CITY OF NEW BEDFORD

CONSTRUCTION OF
SIDEWALK / DRIVEWAY

Driveway Review Form

Address: 310 Summer st.

Driveway Review

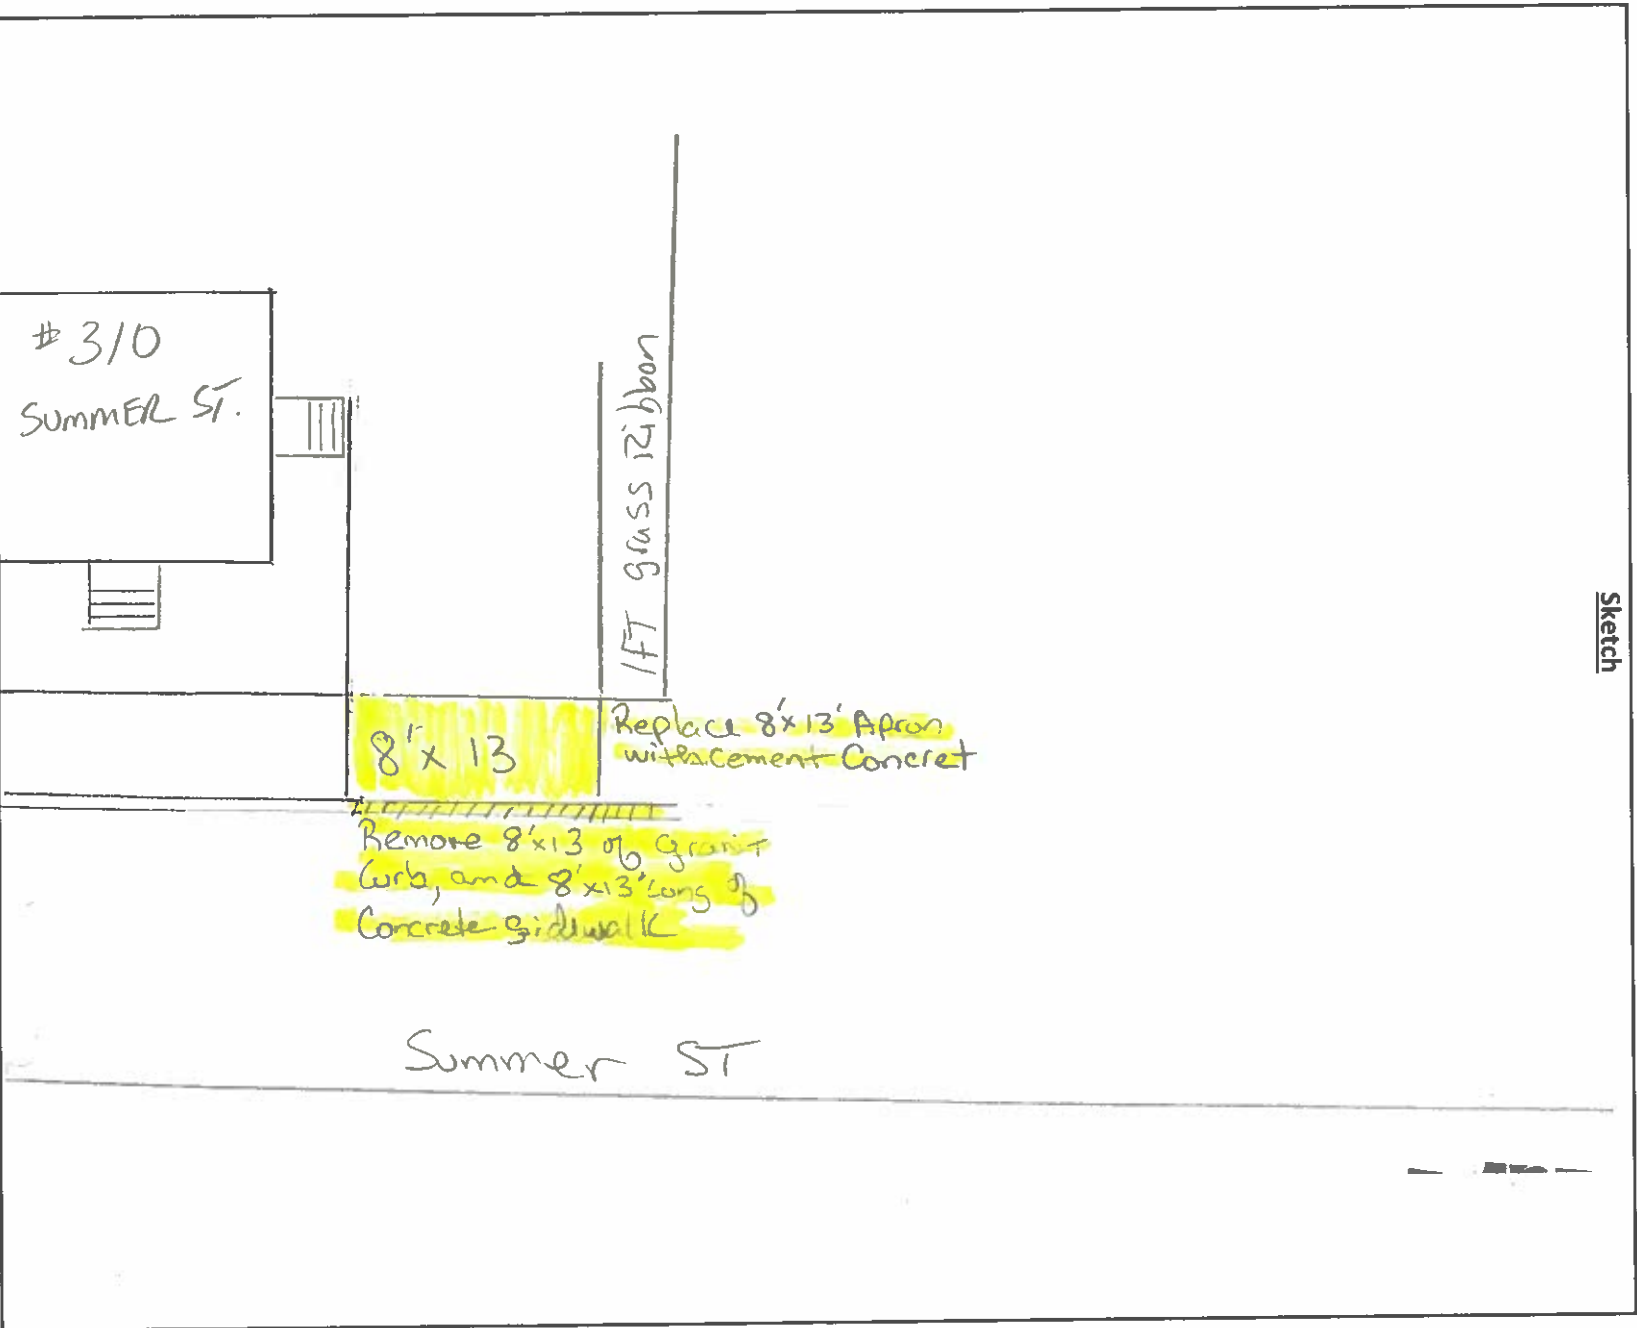
Save aft bigger openings than driveway
Save her 8x13 aft 13g then

Remove Existing concrete, sidewalk and curb 13' and replacing with new 8x13 concrete

1.Removeing and returning13 ft of granite curb 2. Remove 8ft wide x 13ft long of cement concrete existing sidewalk.3. Install new cement concrete 8ft wide x 13ft long apron to City of New Bedford DPI construction standard specs
